APPENDIX H

HYDROLOGY/WATER QUALITY DATA

SUBJECT: Review of Wetland Hydrology Indicators for Big Wave Jurisdictional Delineation
Including Site Visit Commentary

SUBJECT: Hydrologic Analysis of Big Wave Project

Fig. 1: Ponding at Sample Point 5 on 1/10/07 one week after rain.

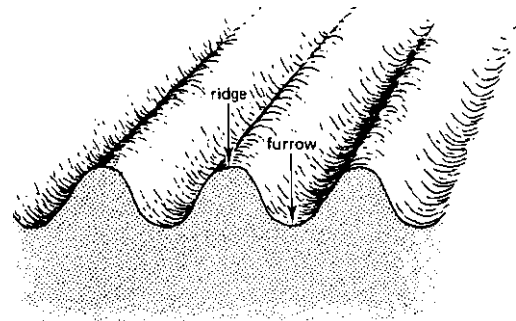
A photograph from the wetland delineation report (Figure 1) shows site conditions at Sample Point 5 on January 10, 2007. The photograph shows standing water near the downhill extent of the cleared field along the western boundary of the site, one week after rain. It is not inherently clear how deep the furrows at the site are relative to the original unplowed ground. Estimates from various sources range from 8 inches to 18 inches, measured from the furrow to ridge as defined in Figure 2. According to the person farming the site, deeper furrows and a berm were created to help manage sediment runoff during the winter.

Standing water was observed at several locations including Sample Point 5 (Figure 1). During the recent site visit, the Applicant's representatives indicated that runoff generated on-site and storm water flowing through the culvert beneath Airport Street ponds at the southwest corner of the site before finding a natural release toward the Pillar Point Marsh at an approximate elevation of 9 feet, which matches previously flown topography. This ponding is the result of a topographic bowl near this location and a relatively thick layer of low permeability clay soil that underlies the shallow tilled and amended soil used for planting. During the winter, nearly all of the runoff generated on- or off-site will find its way to this ponding area. Some hydraulic gradient is required to move the water across the heavily vegetated release point, so one might expect the maximum normal limit of ponded water on site to follow the 9.5-foot or at most the 10-foot contour. The actual release elevation with winter furrows and berming is not directly documented, but the extent of observed standing water due to furrowing can be inferred from CAJA data as described below.

Sample Point 5 is on the ten-foot contour, and 2 inches of standing water was observed in the furrow on February 22, 2007 after flowing runoff had ceased. If the furrows were made at grade (a 1.6 percent slope according to available one foot contours), the "daylight" location of standing water would be about 10 feet "upslope" from Sample Point 5.

Figure 1 - Water Balance

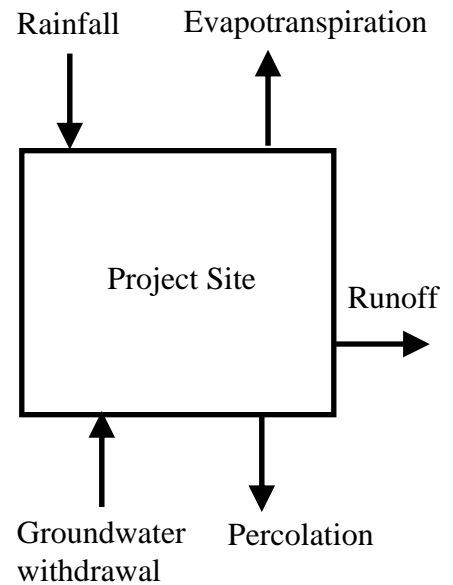
Table 1 presents the water balance from the submitted project information, with the value in most of the rows following from the one or ones before it. The Chart 1.10 from the applicant's Facilities Plan can also be referred to. Values are in gallons per day (gpd). Balances for both "normal" rainfall years and drought years are given. These categories and values for the normal year are then discussed in the sections that follow. To analyze a mass balance for accuracy, it is important to "draw a box" around the processes and area (the system) being analyzed. We can thus draw a box around the project parcels (above the groundwater level) to analyze the net withdrawals or contributions. Figure 1 presents a graphic of this analysis. Groundwater supply and rainwater are the external inputs. Evapotranspiration, stormwater runoff, stormwater percolation, and recycled water percolation are the outputs. There are other potential inputs, including imported water, and potential outputs, including consumptive use.

Rainwater infiltration is not particularly relevant in the water balance for our analysis. The existing site receives the same rainfall that the project site will receive. Both existing and project conditions allow for infiltration of received stormwater with some runoff. Given the design of the porous pavements onsite, there may be additional storage capacity, thus reducing stormwater runoff for a given storm event and even increasing site percolation for certain areas of the site. Overall, however, as detailed below, net runoff is estimated to increase. The applicant's indication that stormwater infiltration will contribute additional water for groundwater recharge is not, therefore, consistent with our calculations.

It is difficult to precisely estimate the quantities of water that would be consumed or taken out of the system by these various processes. Nevertheless, it can be noted that a perfectly closed water recycling loop does not seem reasonable and may be somewhat optimistic. If these consumptive uses were estimated to account for 10% of the water demand, then only 9,000 gpd would be available for recycling versus the entire 10,000 gpd. For the present analysis, these discrepancies have been ignored. As mentioned above, any internal recycling within the system is not relevant to a groundwater recharge analysis.

Overall, since evaporation as an output is estimated to consume most of the applied 10,000 gpd, which is equivalent to the main groundwater input, the system will effectively be taking 10,000 gpd from the groundwater. In other words, a net withdrawal of almost 10,000 gpd is expected.
